PRODUCT CHANGE NOTIFICATION

POWER INDUCTORS

Bourns® Model PQ2614BHA, PQ2614BLA and PQ2617BHA Series Shielded Power Inductors

Change to Mounting Platform and Additional Mounting Platform Alternate Supplier

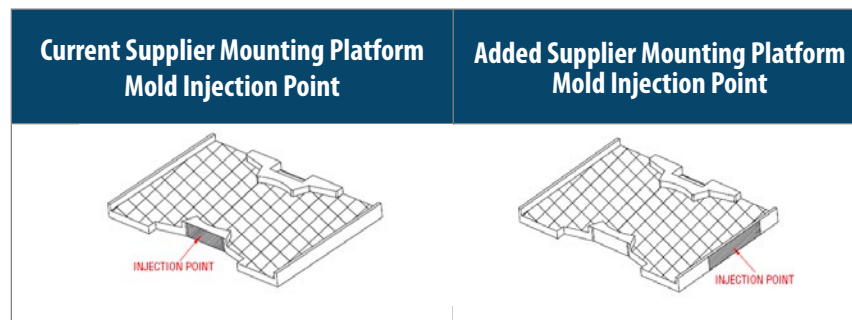
Riverside, CA – October 11, 2019 – Bourns is changing the mounting platform design of the Model [PQ2614BHA](#), [PQ2614BLA](#) and [PQ2617BHA](#) Series Shielded Power Inductors. The change will slightly increase the extension of the clip terminal below the base from 0 - 0.1 mm to 0.1 – 0.2 mm. The design modification will improve mounting coplanarity of the inductor. A list of affected part numbers is shown on the following page.

The fit of the inductor will change due to the mounting platform redesign. The form and function remain unchanged. The quality and reliability of the inductor will be improved.

In addition to the redesign of the mounting platform, an alternate supplier for this material has been qualified and included in the AVL to improve flexibility of material management and sourcing lead time. The material appearance of the current and alternate supplier is different because of the position of the mold injection point.

The fit of the inductor will have two versions depending on the mounting platform supplier. The form, function, quality and reliability remain unchanged.
